Date:	Issued:
01/17/16	Schematic Revision Options

YMCA Camp Jewell  
6 Prock Hill Road  
Colebrook, Connecticut

Cabin #3  
Schematic Options for  
Separate Cabin Entrances

Drawing No. A-1

3 North Elevation: Potential Revisions

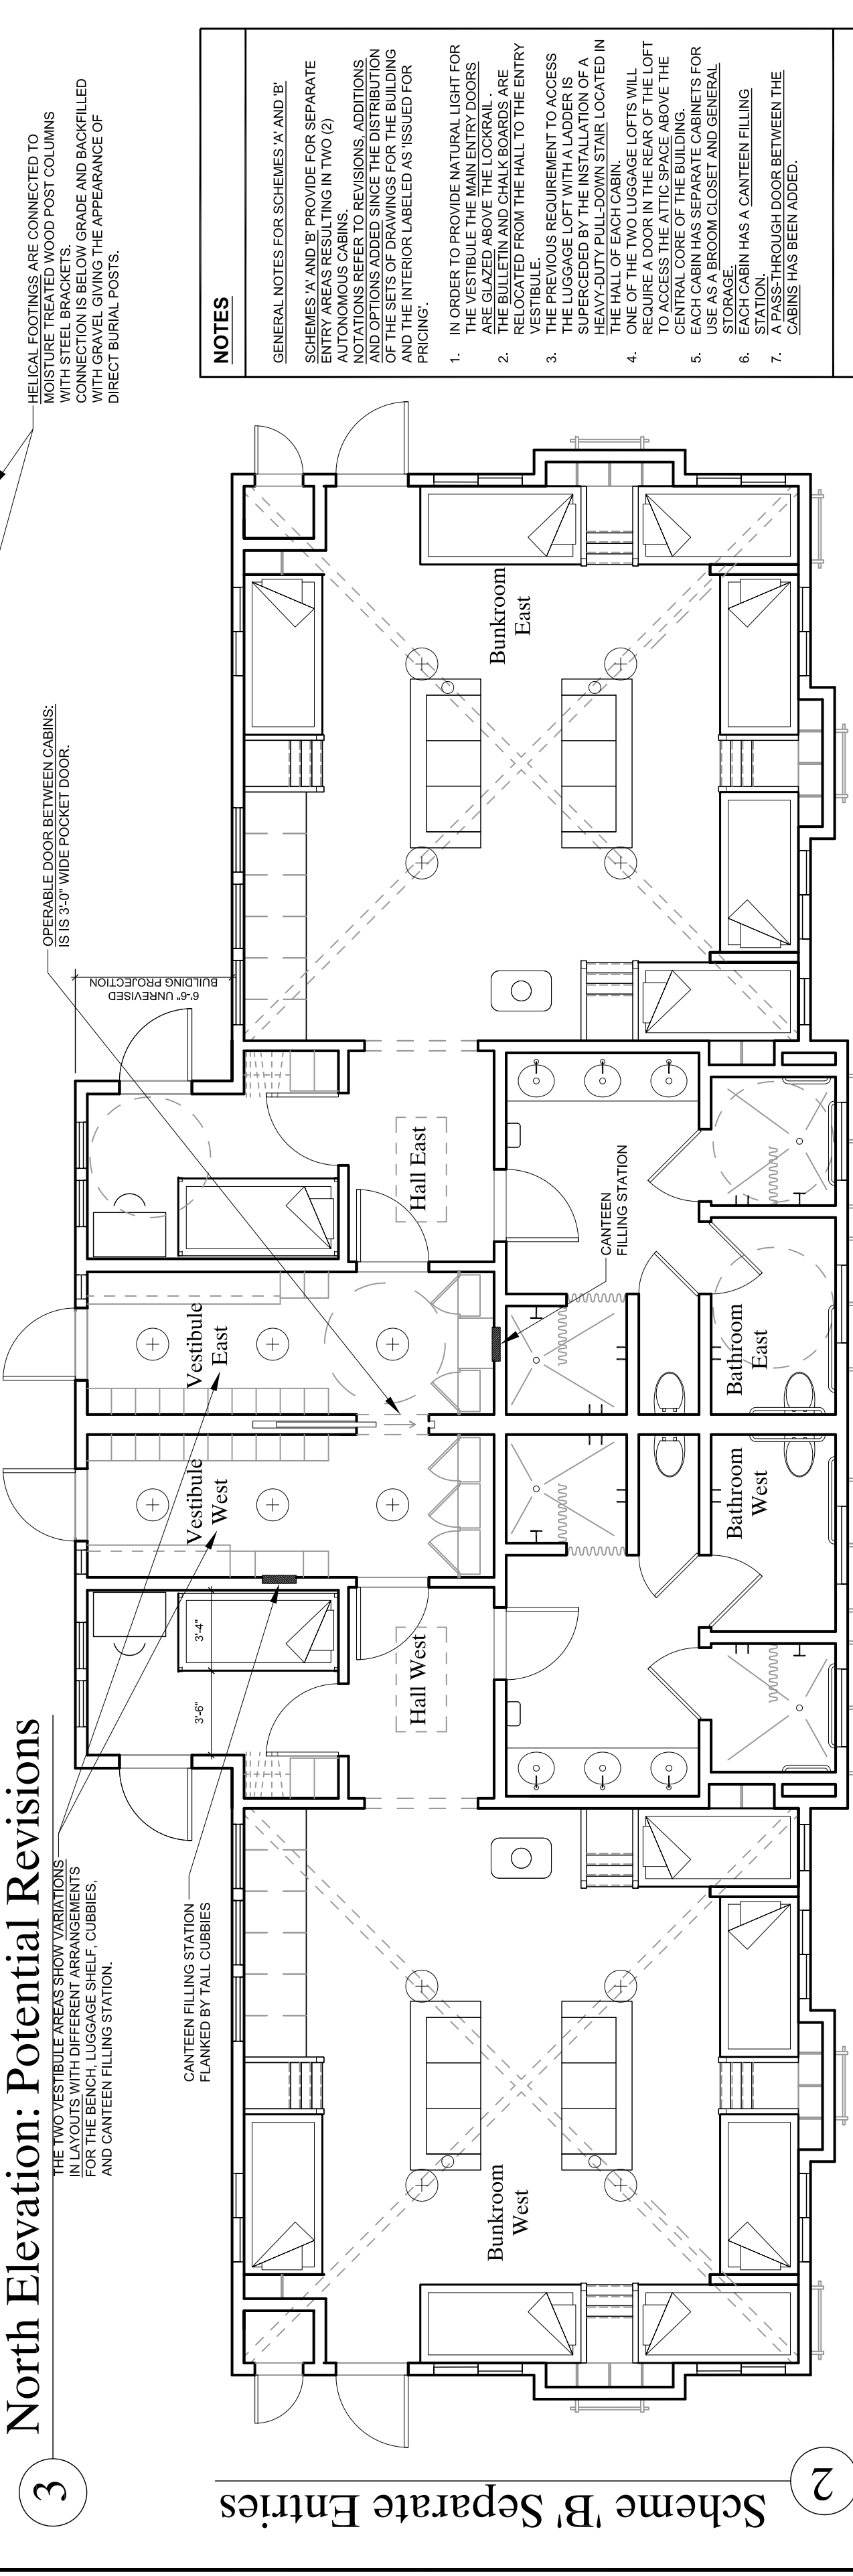
- THE MAIN ENTRY SHOWS FIXED SIDELIGHTS WHICH COULD BE ELIMATED, ASSUMING FOR VENTILATION DURING THE WINTER WITH A HAND CRANK COULD BE ADDED ABOVE EACH ENTRY DOOR. AN OPERABLE DOOR COULD BE ADDED ABOVE EACH ENTRY DOOR. VENTILATION WALL BENCHES IN THE ENTRY VESTIBULE.

1 Scheme 'A' Separate Entries

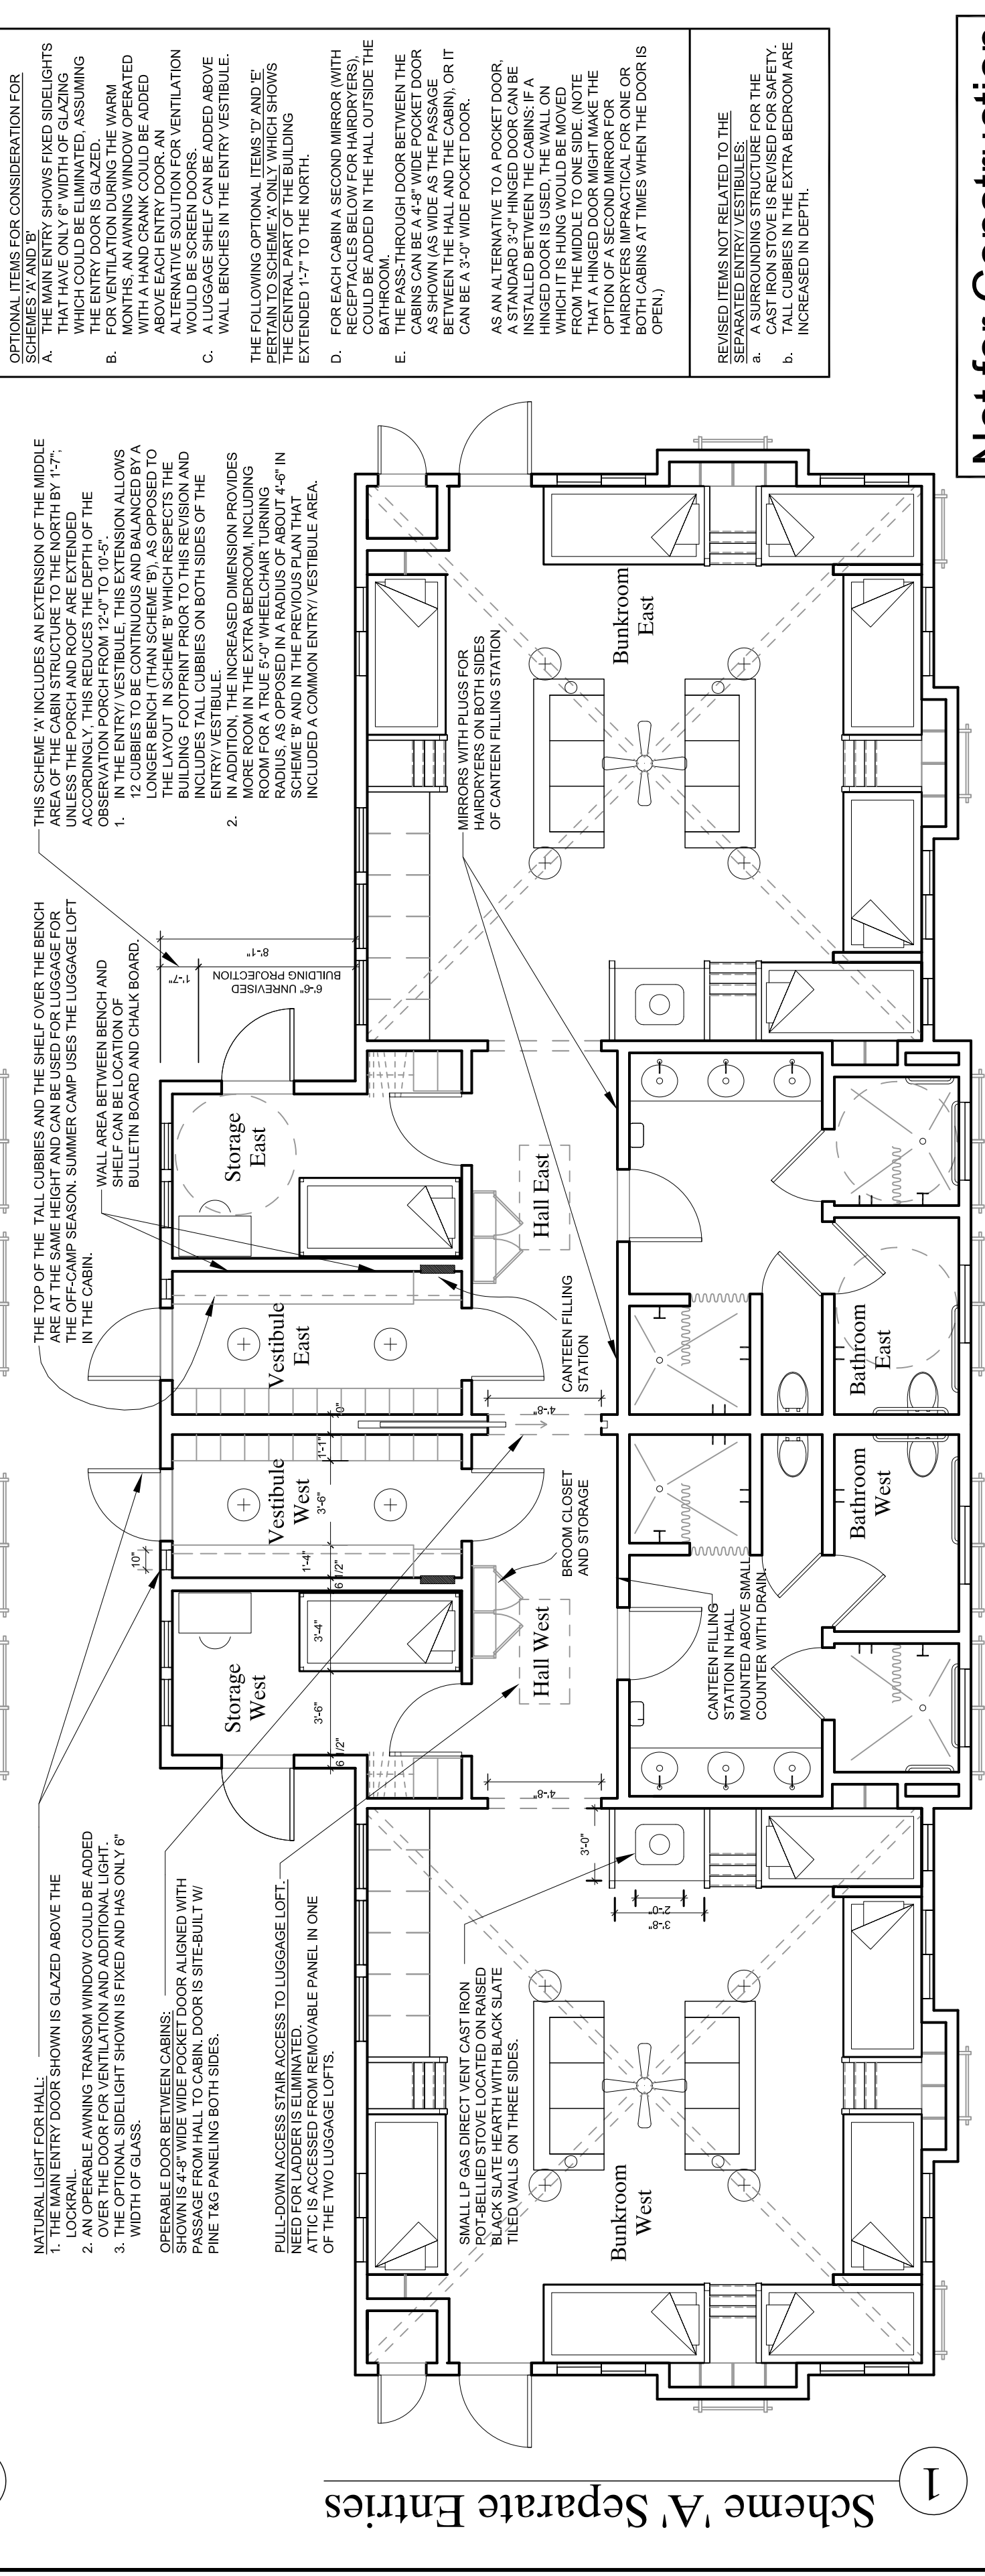
SCHEMES 'A' AND 'B' PROVIDE FOR SEPARATE CABIN ENTRIES IN TWO (2) AUTONOMOUS CABINS. NOTATIONS REFER TO REVISIONS, ADDITIONS, DELETIONS, AND DIMENSIONS OF THE SETS OF DRAWINGS FOR THE BUILDING AND THE INTERIOR LABELED AS 'ISSUED FOR PRICING'.

- IN ORDER TO PROVIDE NATURAL LIGHT FOR THE VESTIBULE THE MAIN ENTRY DOORS WILL BE RELOCATED TO THE PERIPHERY OF THE BUILDING AND CHALK BOARDS ARE TO BE RELOCATED FROM THE HALL TO THE ENTRY.
- THE BULLETIN BOARD REQUIREMENT TO ACCESS THE LUGGAGE LOFT WITH A LADDER IS SUPERSEDED BY THE INSTALLATION OF A LUGGAGE LOFT WITH STAIRS LOCATED IN THE HALL OF EACH CABIN.
- ONE OF THE TWO LUGGAGE LOFTS WILL REQUIRE A DOOR IN THE AREA OF THE LOFT CENTRAL CORE OF THE BUILDING.
- EACH CABIN HAS SEPARATE CABINETS FOR STORAGE, BROOM CLOSET AND GENERAL STORAGE.
- EACH CABIN HAS A CANTENEN FILING STATION THROUGH DOOR BETWEEN THE CABINS HAS BEEN ADDED.
